Access Compliance Report

Public Rights-of-Way (Curb Ramps)

Intersection ID: N/A	Main Street: CRAIGHEAD_RD	Cross Street: N/A	Location: NW
ADA ID: 1475A3E4A0E8	Ramp Type: PerpDiag	Initial Pass/Fail: Fail	Overall Compliance: No
Codes/Mitigation Info/Possible Solution		Field Measurements/Component Compliance

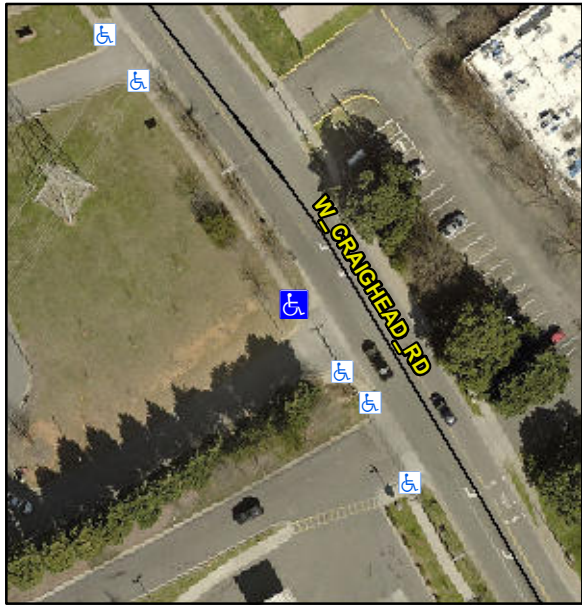
Not Found, R304.2.2, R302.7

Compliance	Description	Data	Compliance	Description	Data
N/A	Ramp Length (in)	151.0	No	Ramp Slope (%)	12.5
Yes	Ramp Width (in)	60.0	Yes	Ramp XSlope (%)	3.8
N/A	Flare Type LT	N/A	N/A	Flare Type RT	N/A
N/A	Flare Slope LT (%)	N/A	N/A	Flare Slope RT (%)	N/A
N/A	Flare Traversable LT?	N/A	N/A	Flare Traversable RT?	N/A
N/A	Landing Length (in)	N/A	N/A	DWS Provided?	N/A
N/A	Landing Width (in)	N/A	N/A	DWS Contrast?	N/A
N/A	Landing Slope (%)	N/A	N/A	DWS Length (in)	N/A
N/A	Landing X Slope (%)	N/A	N/A	DWS Full Width?	N/A
N/A	Landing Curb? (Y/N)	N/A	N/A	DWS Offset (in)	N/A
N/A	Shared Landing?	N/A			
N/A	Gutter Ponding?	N/A	N/A	Gutter Slope (%)	N/A
N/A	Gutter Lip Ht (in)	N/A	N/A	Gutter X Slope (%)	N/A
N/A	Painted X Walk1?	No	N/A	Painted X Walk2?	No
	X Walk 1 Direction	To S		X Walk 2 Direction	To E
N/A	X Walk 1 Width (in)	N/A	N/A	X Walk 2 Width (in)	N/A
	X Walk 1 Slope (%)	2.3		X Walk 2 Slope (%)	4.6
	X Walk 1 X Slope (%)	3.8		X Walk 2 X Slope (%)	3.1

N/A	Ramp inside XWalk1?	N/A	N/A	Ramp inside XWalk2?	N/A
	Road Slope (%)	4.5	N/A	Clear Space?	N/A
	Road X Slope (%)	0.8	N/A	Clear Space to XWalk (in)	N/A
N/A	Any Obstructions?	N/A	N/A	Storm Grate/Utility Hazard?	N/A
	Obstruction Type			Storm Grate/Utility Type	
		N/A			N/A
			No	Surface Condition? (G/P)	Poor

Remove & Replace Curb Ramp With Two New Directional Ramps or Equivalent.
